## Technical Bulletin # TCB14

**Transmission: 42RLE**

**Subject: Intermittent code P1740**

**Application: Dodge, Chrysler and Jeep**

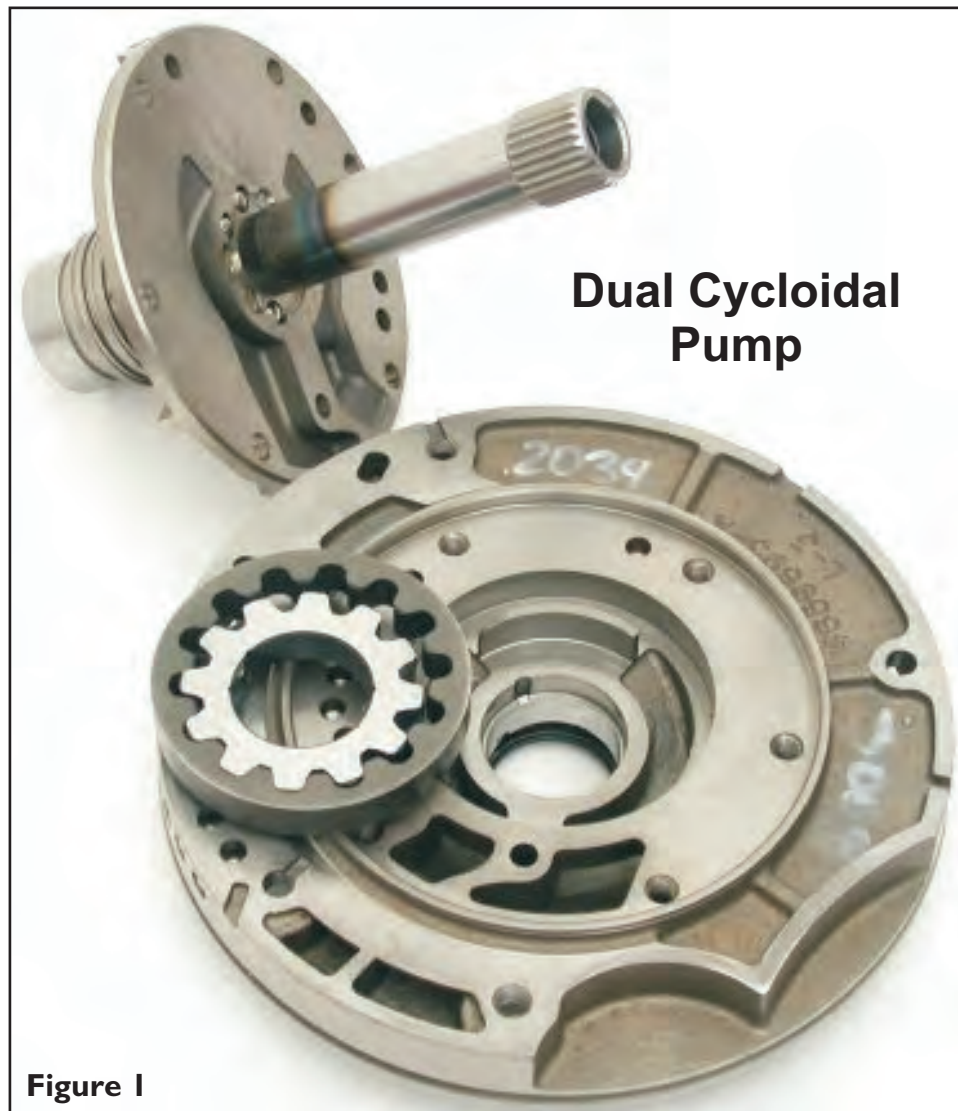
A Dodge, Chrysler or Jeep vehicle equipped with a 42RLE transmission setting a very intermittent code P1740. These are late 2003 & up vehicles with a Dual Cycloidal gear style pump (figure 1). The pump may look factory new in every way. Replace the pump body with an early 4ITE Crescent gear type pump body (figure 2), it is not necessary to change the pump stator.
